# HISTORIC AND DESIGN REVIEW COMMISSION

March 17, 2021

**HDRC CASE NO:** 2021-100  
**ADDRESS:** 415 MISSION ST  
**LEGAL DESCRIPTION:** NCB 946 BLK 2 LOT 22  
**ZONING:** RM-4 H HS  
**CITY COUNCIL DIST.:** 1  
**DISTRICT:** King William Historic District  
**LANDMARK:** Individual Landmark  
**APPLICANT:** Fernando De Leon/One Stop Code Consulting  
**OWNER:** Jake Jazdzewski/JAZDZEWSKI JAKE & MONICA  
**TYPE OF WORK:** Relocation and exterior modifications to rear accessory structure  
**APPLICATION RECEIVED:** February 22, 2021  
**60-DAY REVIEW:** Not applicable due to City Council Emergency Orders  
**CASE MANAGER:** Stephanie Phillips  
**REQUEST:**

The applicant is requesting conceptual approval to:

drawing title:  
PROPOSED REMODEL /  
PLANS & ELEVATIONS

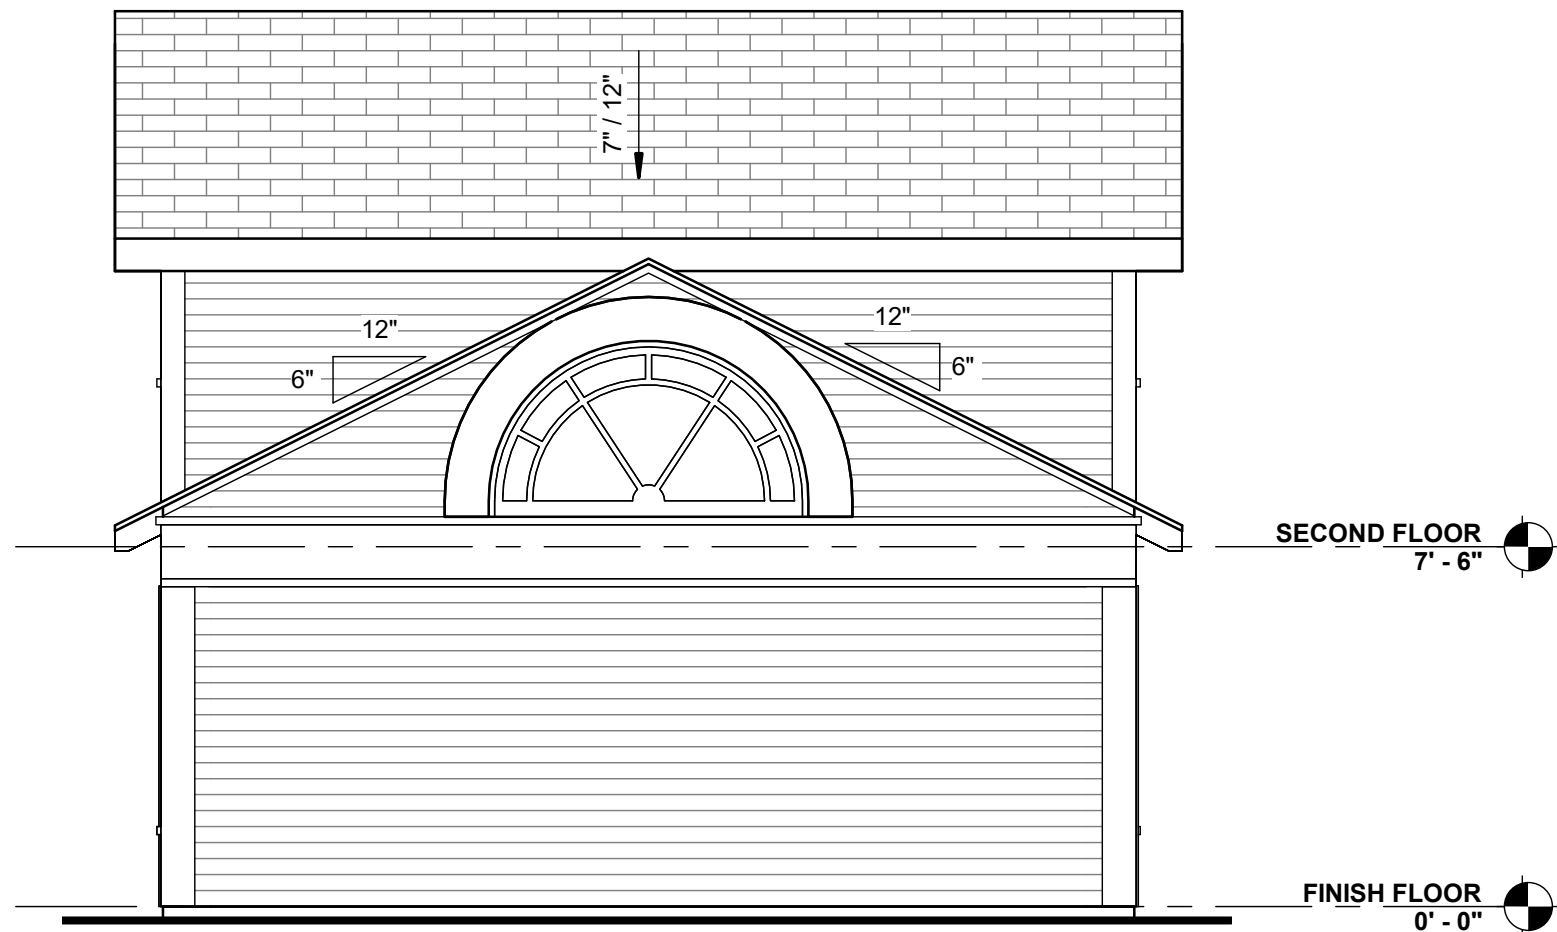
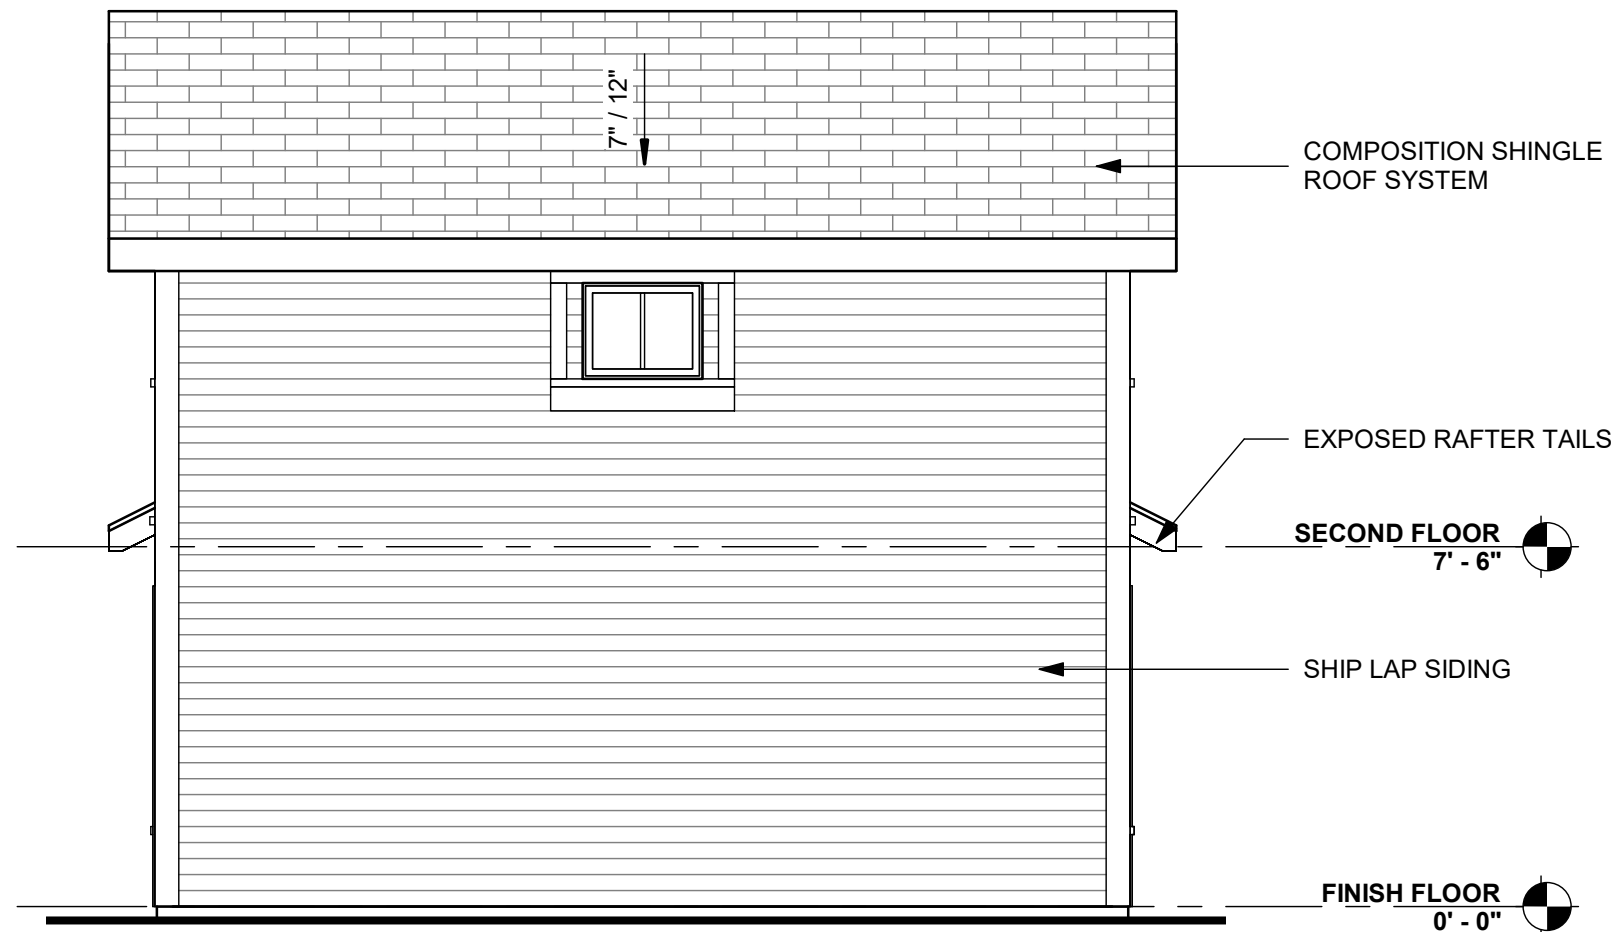
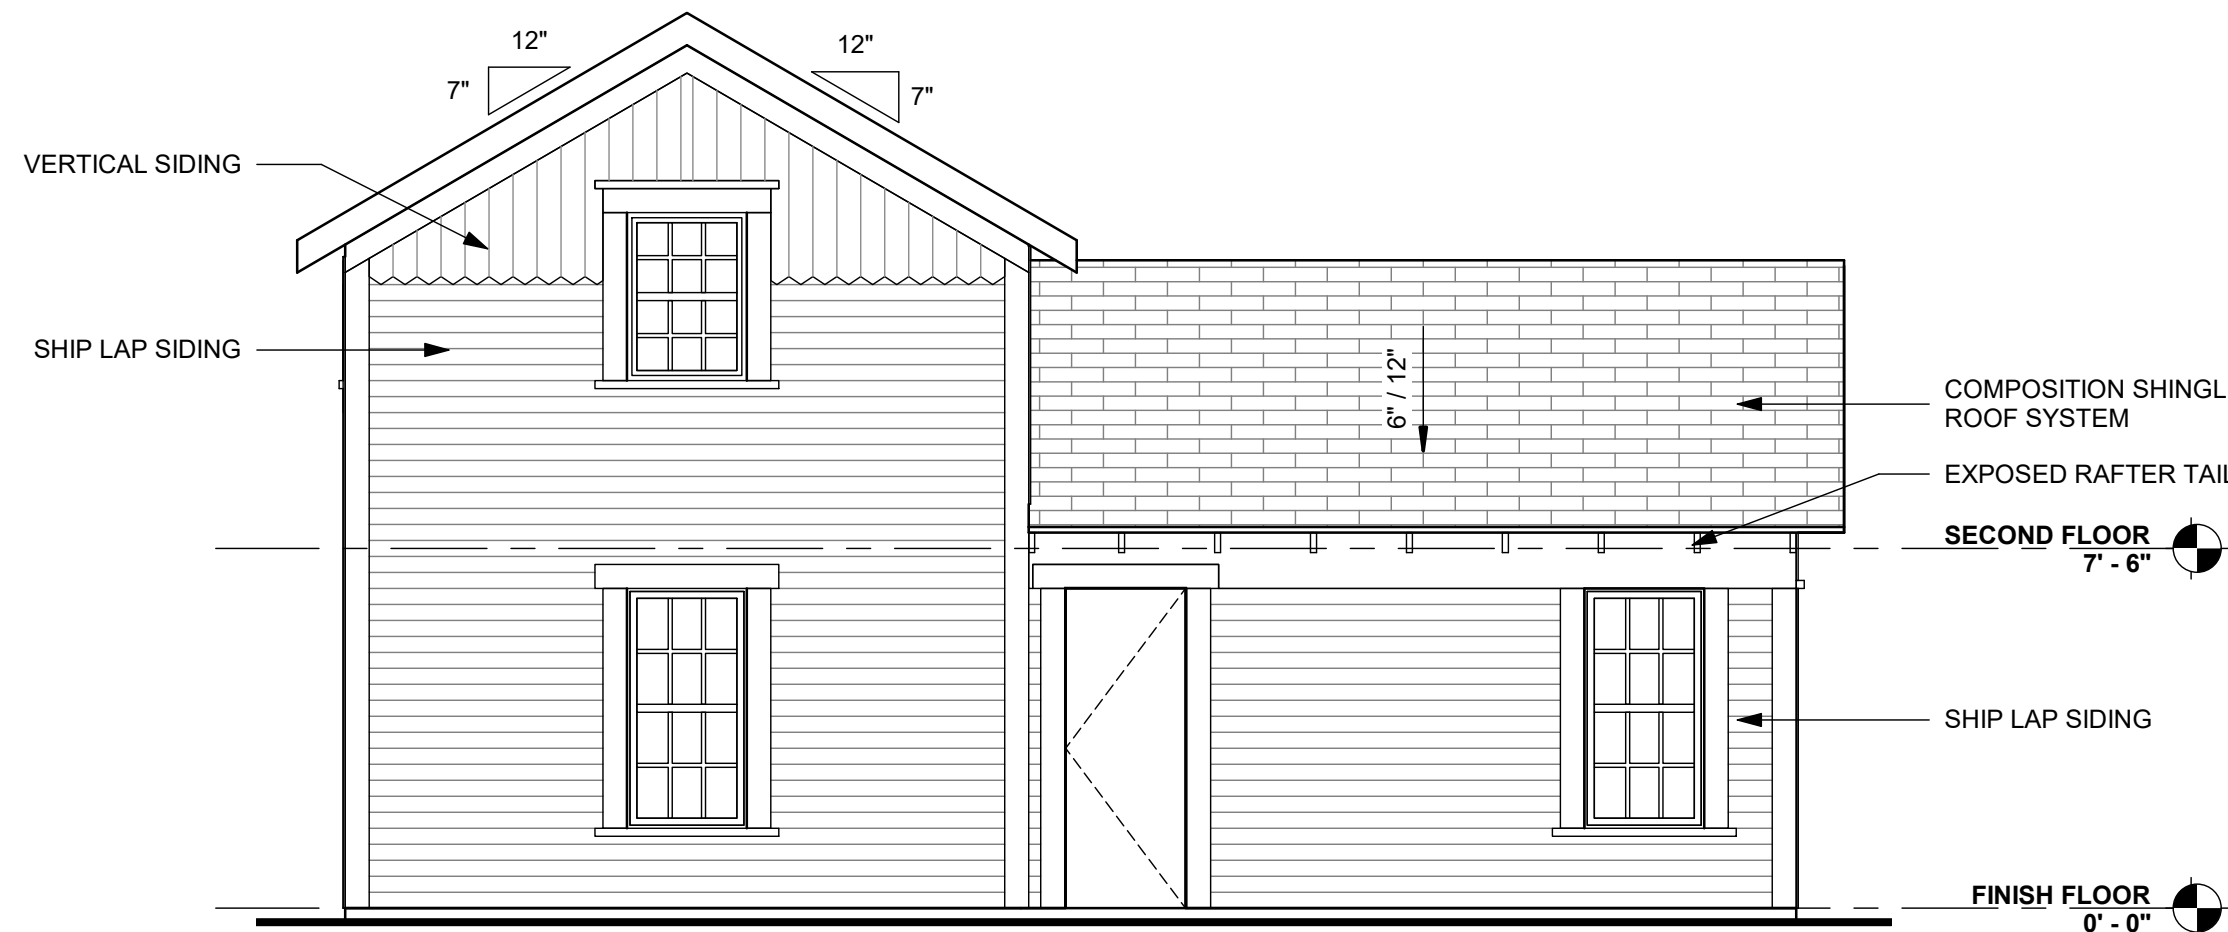
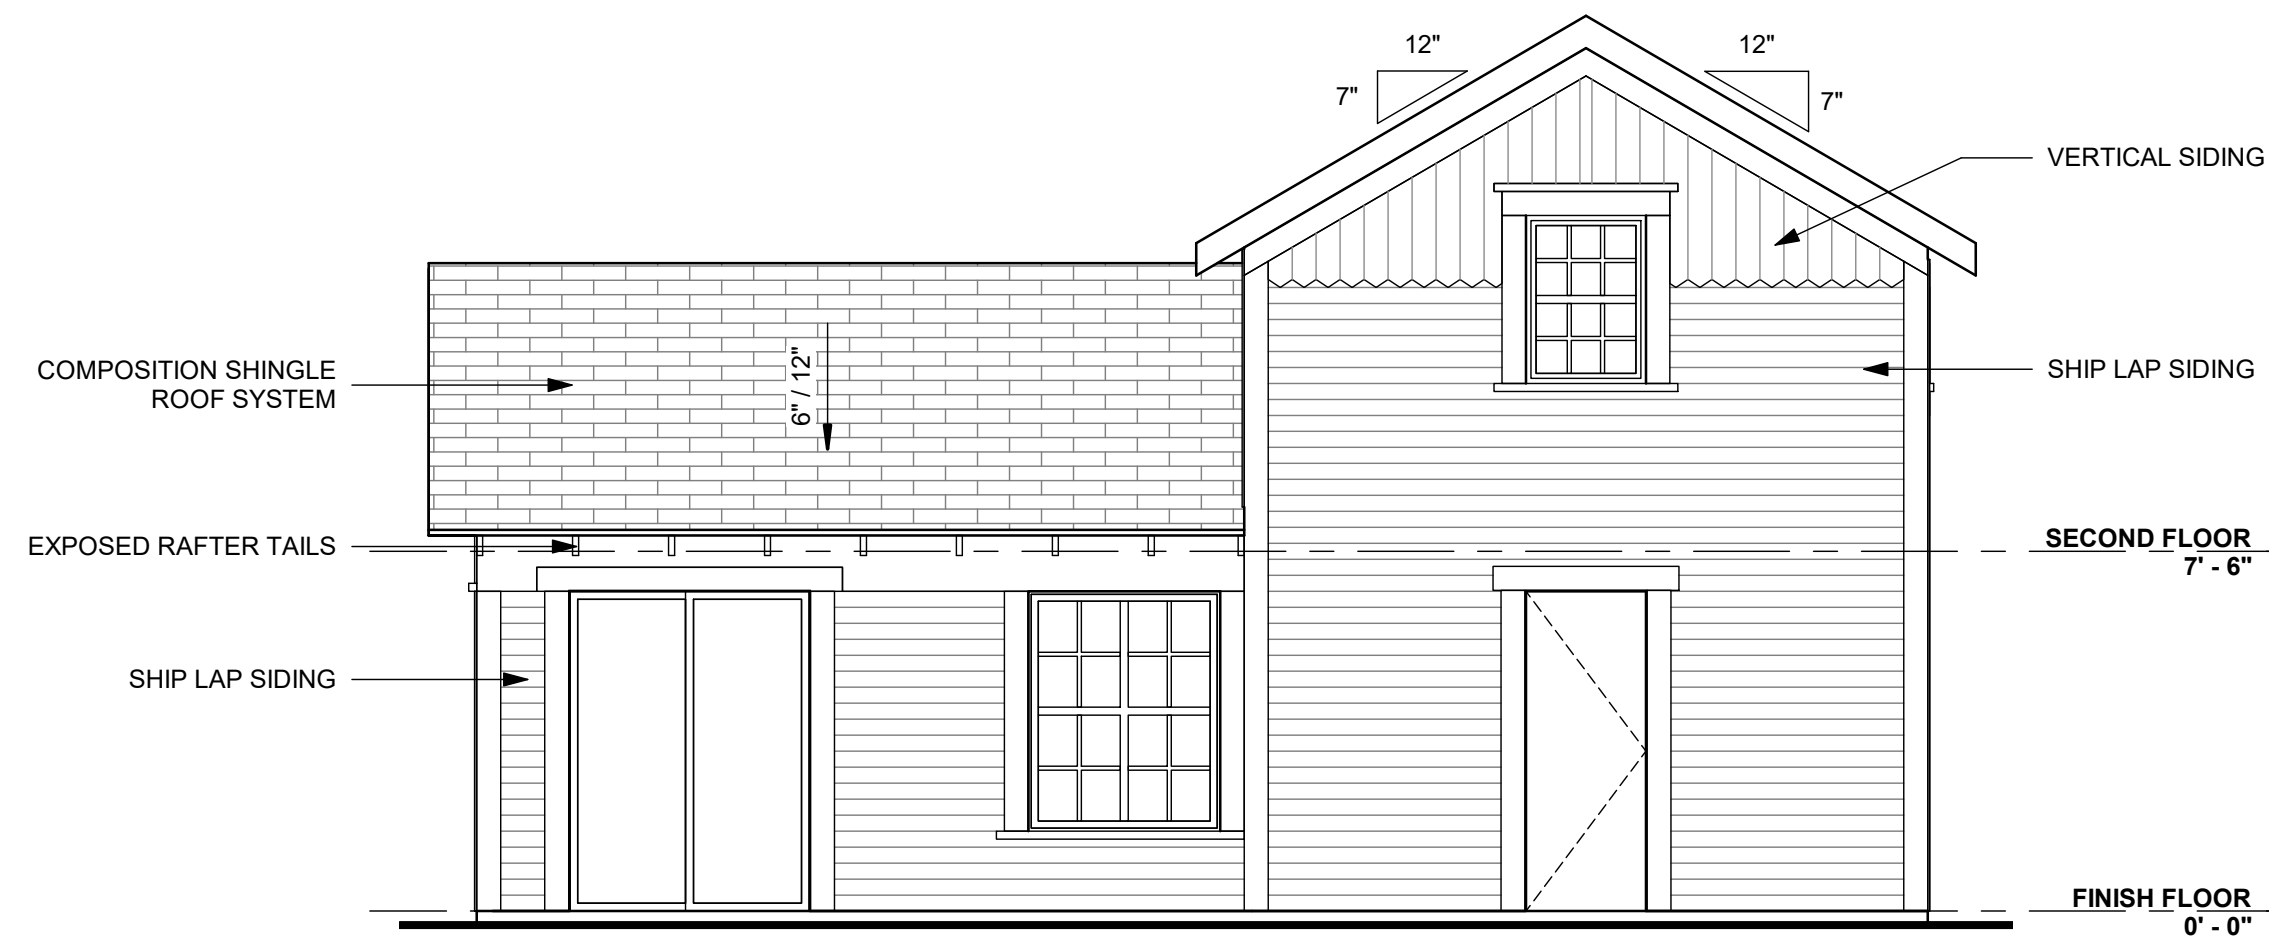
- e. **FENESTRATION MODIFICATIONS** – The applicant has proposed to replace an existing second story door at the stair landing with a new window to match existing in terms of scale, proportion, configuration, and inset. The awning above the door will also be removed. Staff generally finds the request appropriate, but finds that the door should be retained and reused elsewhere on the structure, or stored on the property. Additionally, the applicant has proposed to remove an existing first floor window and enclose with siding on the back elevation. An existing second story window on this elevation will be retained. Staff generally finds the request acceptable based on its limited visibility from the public right-of-way and the retention of an additional opening, but finds that the window should be retained and reused elsewhere on the structure, or stored on the property. Staff also finds the addition of new sliding doors on an ancillary elevation to be appropriate.

- f. **GARAGE BAY ENCLOSURE** – The applicant has proposed to enclose the open garage bay with siding to create interior space. The garage is the single story mass of the rear accessory structure and faces the primary structure. The garage does not serve a driveway, rear alley, or other parking access or configuration and is located to the west of the driveway in the rear yard. Staff finds the enclosure of the garage bay acceptable due to its limited visibility from the public right-of-way and the fact that the remaining elements of the structure, including all walls, the front half circle window, and the vertical trim pieces, will be retained, rendering the intervention reversible.

- g. **WINDOW REPLACEMENT** – The applicant has proposed to replace all existing windows with new aluminum clad wood windows per the submittal documents. The applicant has not provided photographs of the existing window conditions. At this time, staff requires additional information to make an official determination on appropriateness, including a window schedule and photographs of the condition of each existing window. Staff recommends window

- i. That the applicant retains the existing windows and doors to be removed and reuses them in other openings on the structure, to include the replacement of windows deteriorated beyond repair if applicable, or keeps them onsite for future use as noted in findings e and f.

- ii. That the applicant submits a comprehensive window schedule and photographs of each window requested to be replaced for final approval to determine the appropriateness of window replacement as noted in finding h. Staff strongly encourages window repair and restoration wherever feasible, which is eligible for administrative approval.

- iv. That the applicant provides information on the proposed new siding to be used and all final material specifications for final approval.
